SITE PLAN & GENERAL NOTES

ADVANCED MEDICAL IMAGING

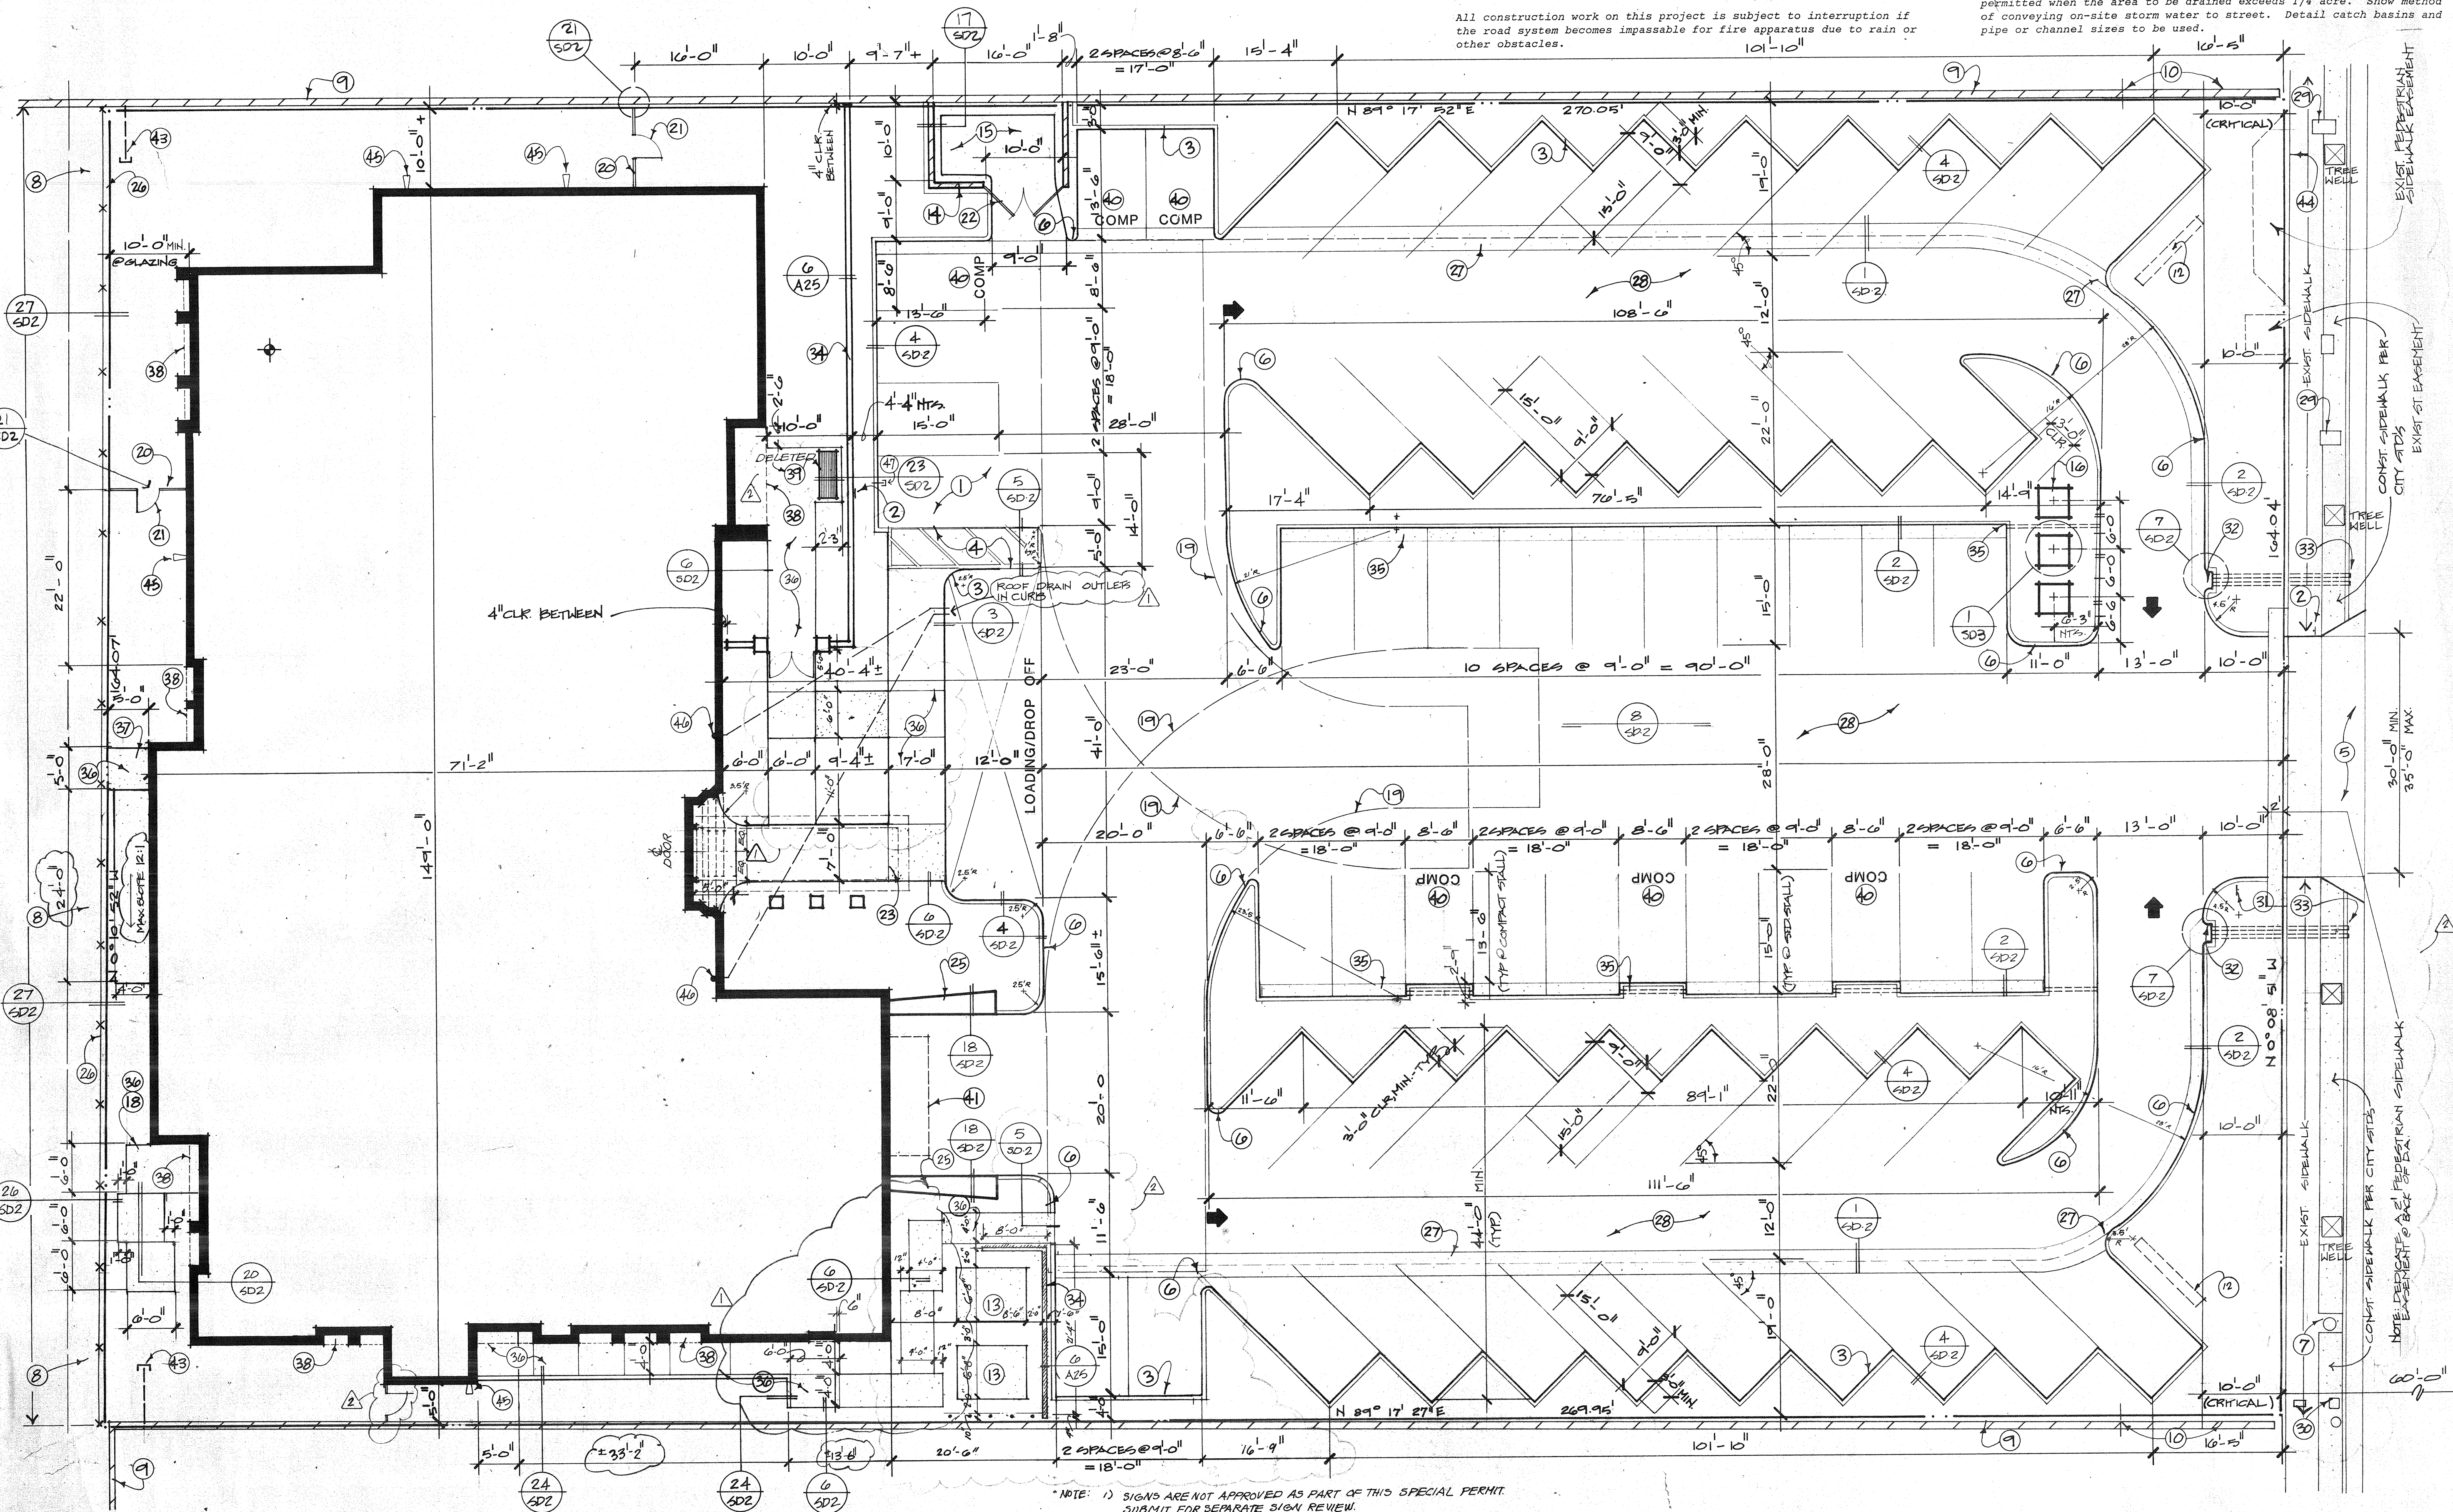
Open cut is not permitted. All utility connection must be bored.
 Connection of sewer house branch requires a machine core to the existing 18 inch line.

All existing driveway approaches which no longer provide access to approved vehicle parking areas shall be removed. Unless otherwise approved by the city engineer, such areas shall be reconstructed with curb, gutter and sidewalk to match existing adjacent street improvements. This work shall be completed and accepted before a permit of occupancy is issued or the building is occupied.
 Authority: FNC 11-209.

Landscaping must be in place before issuance of the certificate of occupancy.

All construction work on this project is subject to interruption if the road system becomes impassable for fire apparatus due to rain or other obstacles.

Deed(s) of Easement(s) for the required dedication(s) shall be prepared by the owner/developer's engineer and submitted to the City with verification of ownership prior to issuance of building permits.

For street tree well requirements, in the public right of way area, submit landscape site plan(s) to City of Fresno Parks Dept. and allow four (4) days for review and recommendations. Contact Parks Division at 498-1551 for proper processing.

Surface drainage over driveway approaches and sidewalks is not permitted when the area to be drained exceeds 1/4 acre. Show method of conveying on-site storm water to street. Detail catch basins and pipe or channel sizes to be used.

A backflow prevention device is required! Contact water division at 498-1408 for requirements; devices must be installed on-site in a location approved by the cross connection control officer; a plumbing permit is required to install devices; backflow prevention devices required shall be installed at the consumer's expense by a qualified journeyman plumber certified as competent for such purposes by the water system manager; backflow devices must be tested and accepted by the water division prior to granting building final; developer is responsible to contact the water division, a minimum of 5 days prior to request for final building inspection.

SUBMIT SMOKE ALARM PLANS TO CITY OF FRESNO FIRE PREVENTION. SPECIFY AN EVENT SEQUENCE FOR TESTING SMOKE DETECTORS FOR THIS SYSTEM.

The well locations are tentative and must be verified by Parks Division. Notify Parks Division to mark tree locations when drive approaches have been completed. Notify Parks Division 72 hours prior to saw cutting or pouring concrete to mark tree well locations and obtain underground clearances (488-1551).

Note: All compact stalls shall be identified with appropriate signage and/or pavement markings.
